DRAWING STATUS
Planning

CLIENT	Mr & Mrs. Ellahi		
PROJECT	91 Devonshire Stree South, Ardwick, Manchester M13 9HY		
DRAWN	A. Ul-Haq	CHKD	AUH

TITLE			
Proposed Single Storey Rear Extension			
<u>Existing & Proposed Plans</u>			
Sheet 1 of 2			
SCALE	DRAWING No	DATE	AMDT
1:50	2022/05/01	Nov. 2022	P1

Proposed Ground Floor Plan

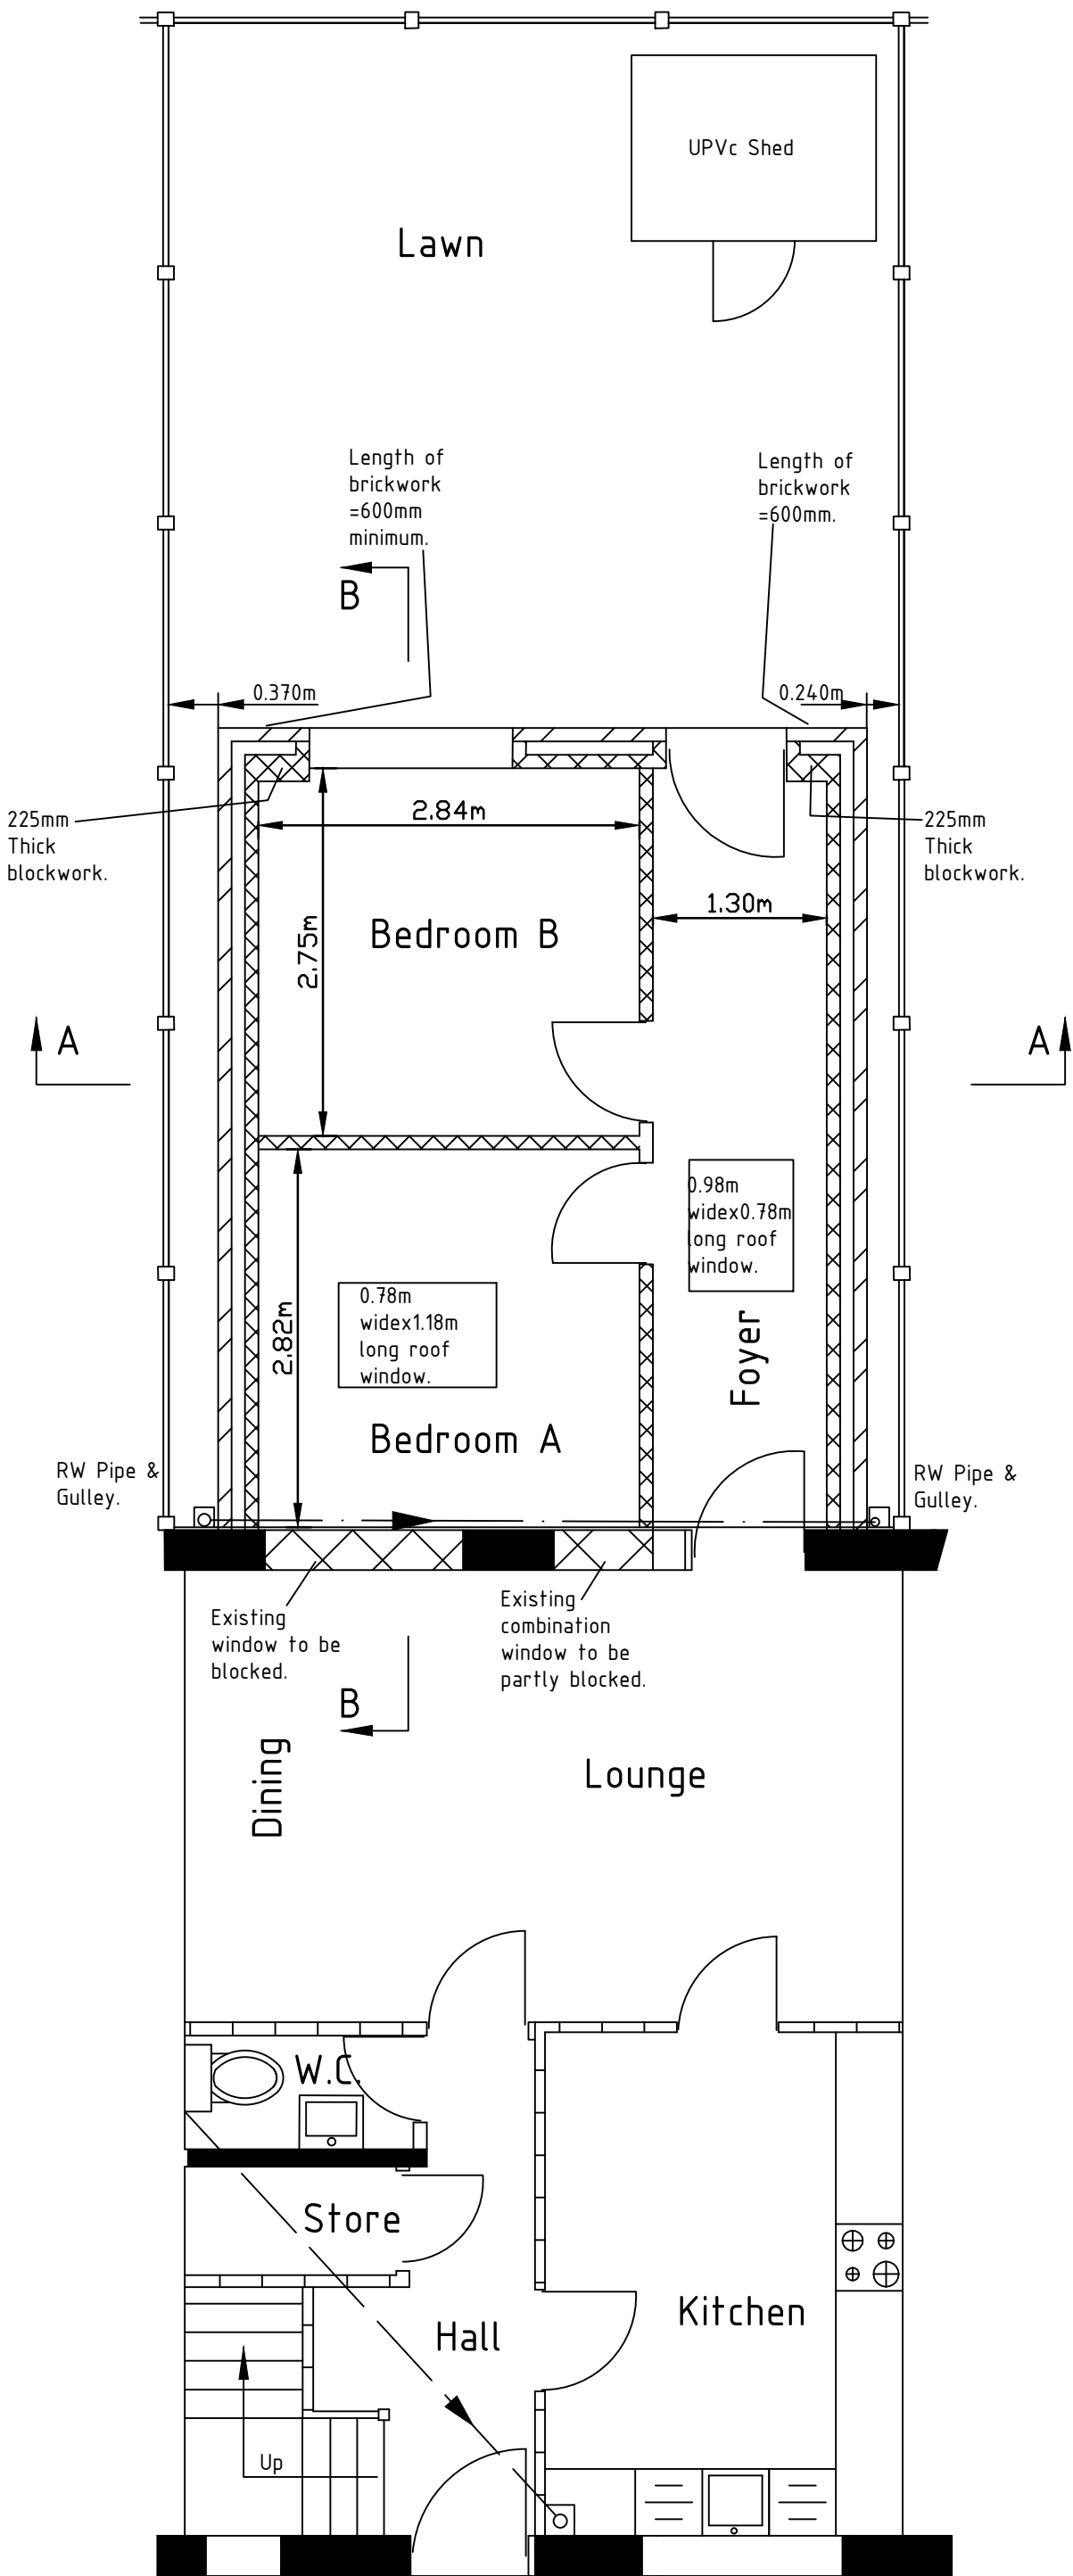
P1	14.02.23	AUH	AUH	The size of the window in Bedroom A amended and the direction of the window in foyer changed. Also notes 20 & 21 above revised.
No	DATE	DRAWN	CHK'D	AMENDMENT

- The roof window to Bedroom A shall be 0.78m wide x 1.18m long, shall be electrically operated and shall have obscure/darkened glazing.
 - The roof window to foyer shall be 0.98m wide x 0.78m long, shall be electrically operated and shall have obscure/darkened glazing.
